CALL NO. 101  
CONTRACT ID NO. 111313  
ADDENDUM # 1

Subject: Jefferson County, HPP 0163 (032)  
Letting April 22, 2011

**The Parklands of Floyds Fork - Project 2A**  
 Backley Creek Park - North  
 Louisville, Kentucky

MODIFICATIONS TO CONTRACT DOCUMENTS:

Drawing Title:  
**WALL 2  
LAYOUT &  
DETAILS**  
Drawing No:  
**SW-2001**

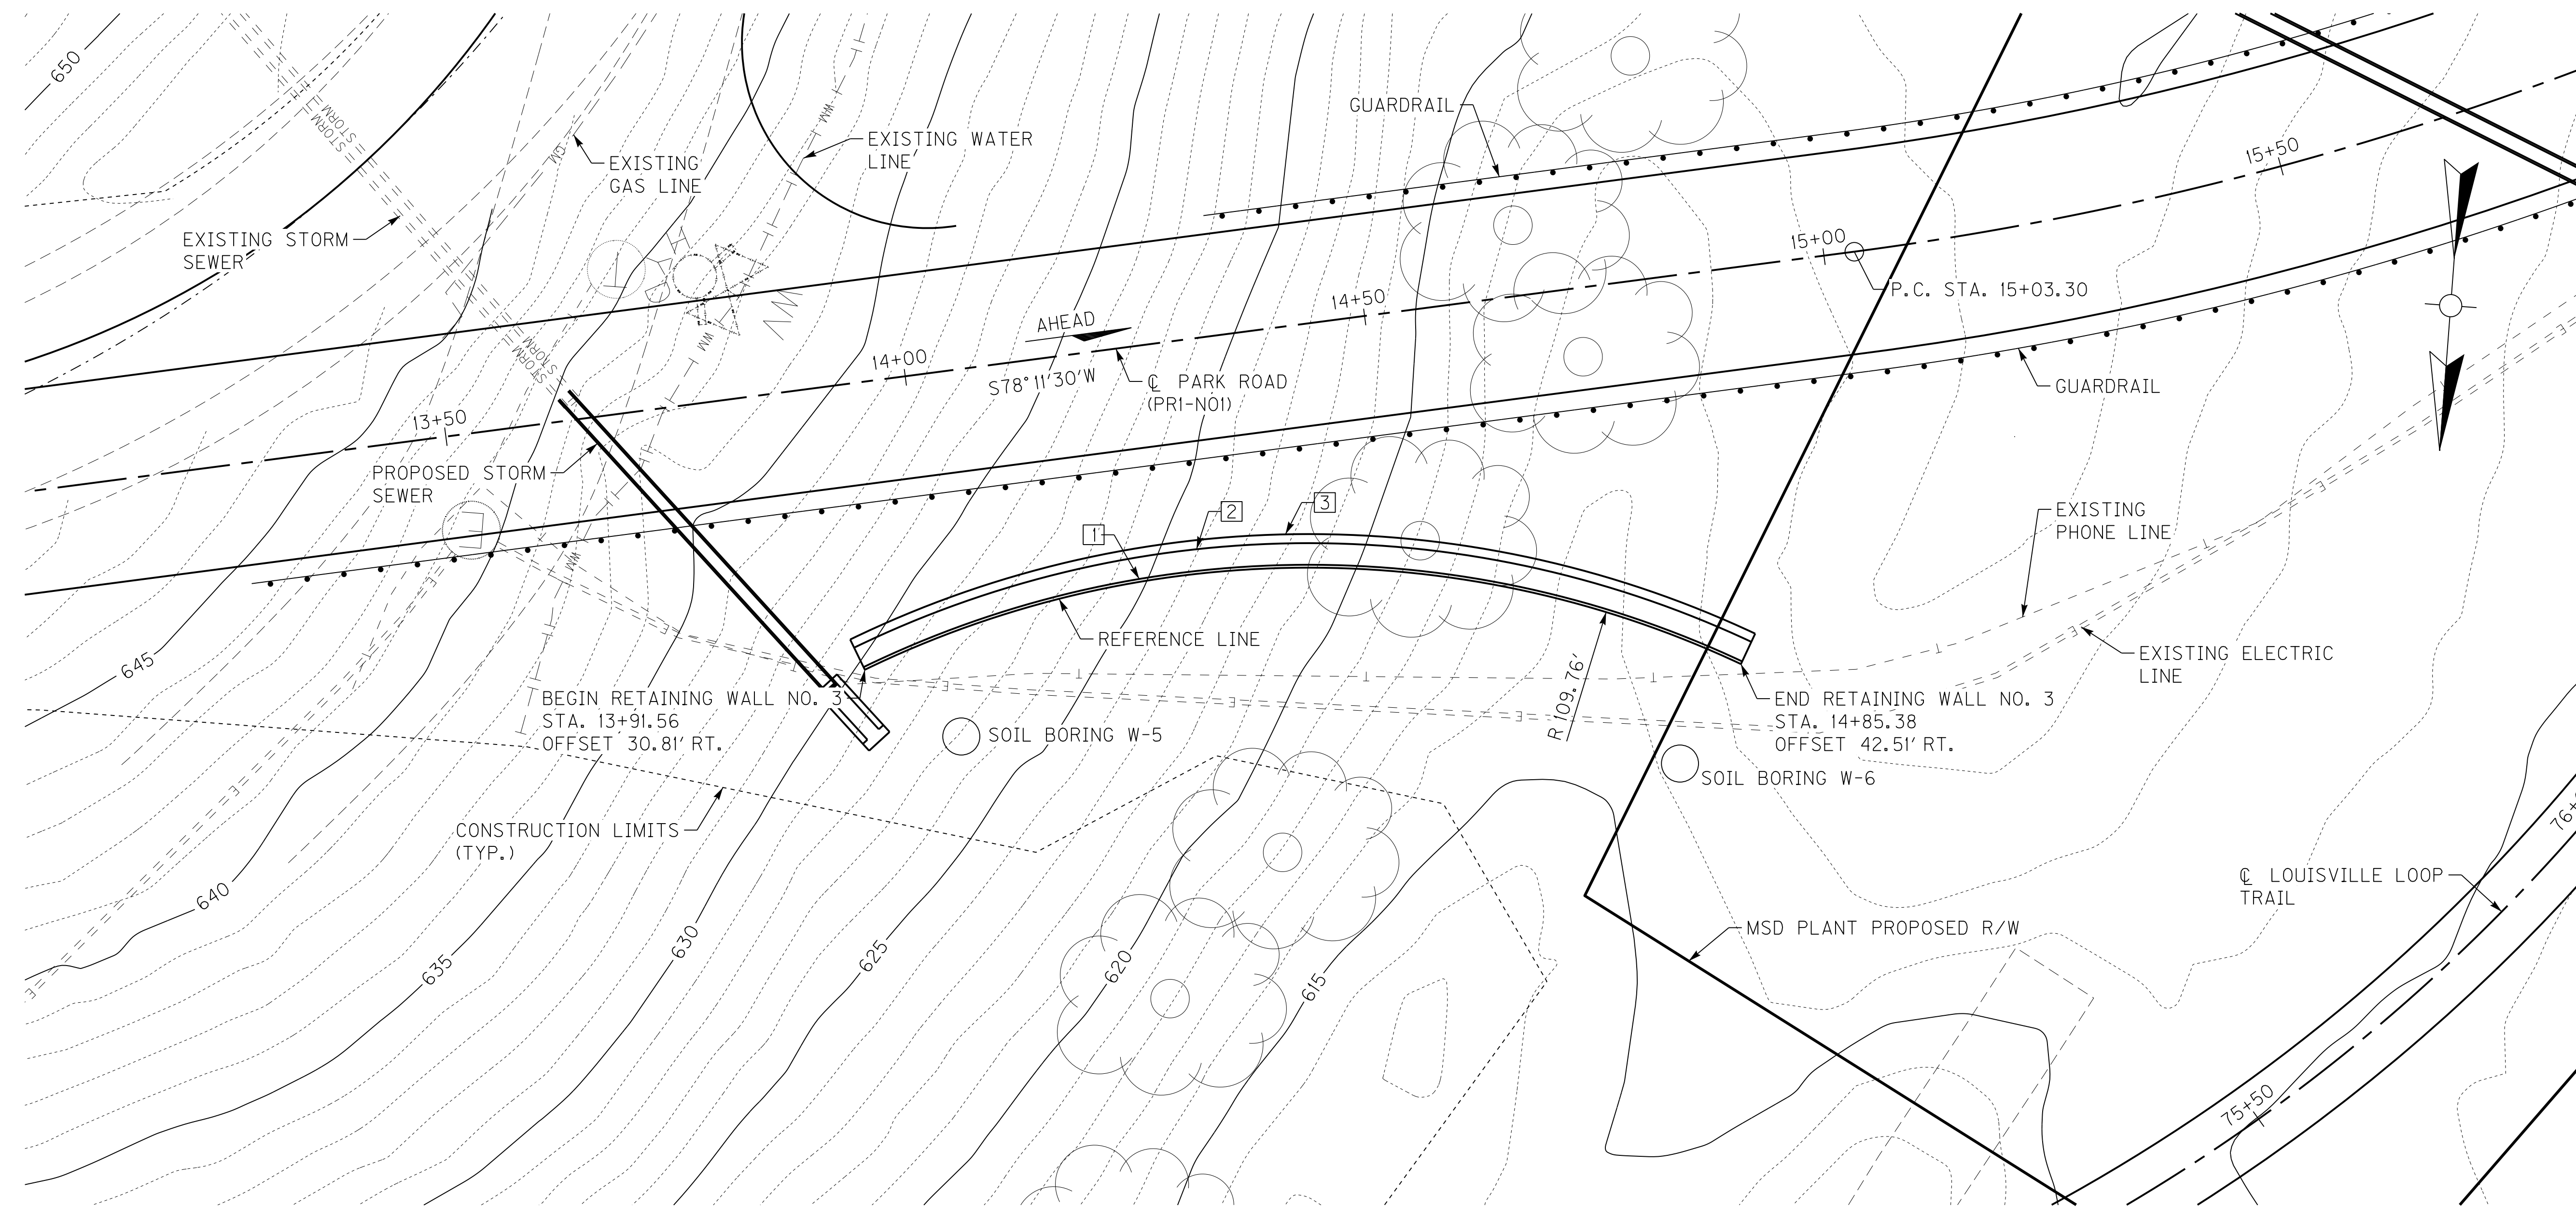
- SW-1001 Revised note to read “The wall block system shall be the Ledgestone series with color scheme “Kentuckiana Buff” as manufactured by Redi-Rock of Kentuckiana, Mt. Washington, KY., or approved equal.
- SW-2001 Revised note to read “The wall block system shall be the Ledgestone series with color scheme “Kentuckiana Buff” as manufactured by Redi-Rock of Kentuckiana, Mt. Washington, KY., or approved equal.
- SW-3001 Revised note to read “The wall block system shall be the Ledgestone series with color scheme “Kentuckiana Buff” as manufactured by Redi-Rock of Kentuckiana, Mt. Washington, KY., or approved equal.
- SW-6001 Revised note to read “The wall block system shall be the Ledgestone series with color scheme “Kentuckiana Buff” as manufactured by Redi-Rock of Kentuckiana, Mt. Washington, KY., or approved equal.
